Clinical Product **UPDATES**

Lifeline and Flexline Passive Locking Systems

Issue: Customers being able to open drawers or top cavity tray without breaking the security seal.

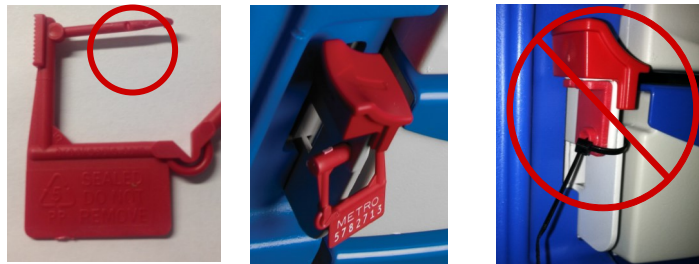
What kind of seal are they using to secure their passive lock?

- Metro Security Seals (LEC320) are designed with a special notch in them to break when the thumb latch is pushed down or the top cavity tray is pushed back.
- Other Seals may stretch far enough to open the top drawer before breaking or not break at all because of factors such as the material of the seal, how tightly the seal is placed and the durability of the seal.

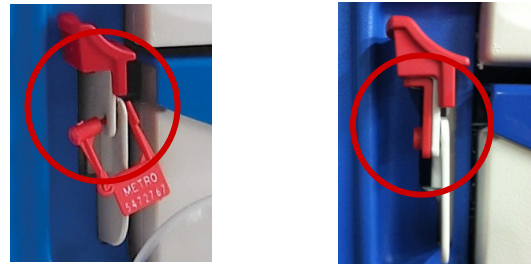
Does the customer have an "L-Shaped Bracket" on their Thumb Latch?

The "L-Shaped Bracket" adds extra space for the seal to break easily.

1. Remove the screw underneath the thumb latch
2. Place the "L-Shaped" bracket on the left side, as shown above
3. Reinsert the screw and tighten

"L-Shaped" Bracket Part Number: **RPLF-TSEAL**

NOTE: This is for current Lifeline and Flexline carts that were manufactured before Oct. 2011, all carts produced after Oct. 2011 had this part in their assembly.
